Access Compliance Report

Public Rights-of-Way (Curb Ramps)

Intersection ID: 30637	Main Street: NORTHSPRINGS_DR	Cross Street: PROVIDENCE_RD_WEST	Location: SE
ADA ID: 44FF7938AB35	Ramp Type: PerpDiag	Initial Pass/Fail: Fail	Overall Compliance: No
Codes/Mitigation Info/Possible Solution		Field Measurements/Component Compliance

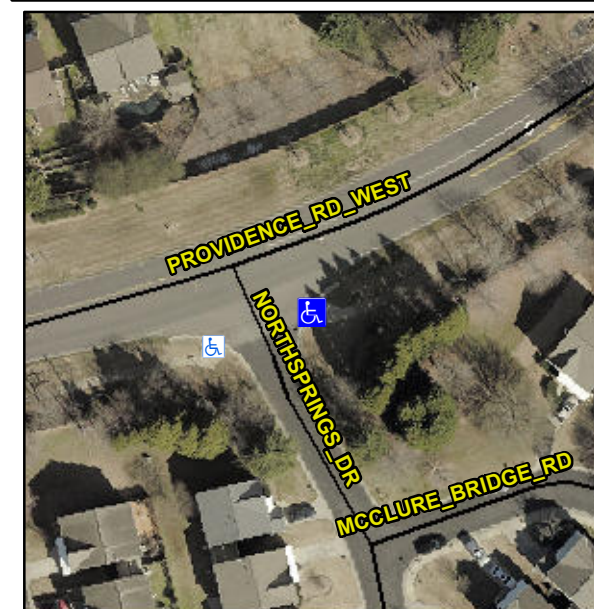
Not Found, R304.5.1, R304.2.2

Compliance	Description	Data	Compliance	Description	Data
N/A	Ramp Length (in)	59.0	No	Ramp Slope (%)	8.6
No	Ramp Width (in)	46.0	Yes	Ramp XSlope (%)	0.6
N/A	Flare Type LT	N/A	N/A	Flare Type RT	N/A
N/A	Flare Slope LT (%)	N/A	N/A	Flare Slope RT (%)	N/A
N/A	Flare Traversable LT?	N/A	N/A	Flare Traversable RT?	N/A
N/A	Landing Length (in)	N/A	N/A	DWS Provided?	N/A
N/A	Landing Width (in)	N/A	N/A	DWS Contrast?	N/A
N/A	Landing Slope (%)	N/A	N/A	DWS Length (in)	N/A
N/A	Landing X Slope (%)	N/A	N/A	DWS Full Width?	N/A
N/A	Landing Curb? (Y/N)	N/A	N/A	DWS Offset (in)	N/A
N/A	Shared Landing?	N/A			
N/A	Gutter Ponding?	N/A	N/A	Gutter Slope (%)	N/A
N/A	Gutter Lip Ht (in)	N/A	N/A	Gutter X Slope (%)	N/A
N/A	Painted X Walk1?	No	N/A	Painted X Walk2?	No
	X Walk 1 Direction	To N		X Walk 2 Direction	To W
N/A	X Walk 1 Width (in)	N/A	N/A	X Walk 2 Width (in)	N/A
	X Walk 1 Slope (%)	7.5		X Walk 2 Slope (%)	2.2
	X Walk 1 X Slope (%)	2.2		X Walk 2 X Slope (%)	4.3

Remove & Replace Curb Ramp With Two New Directional Ramps or Equivalent.
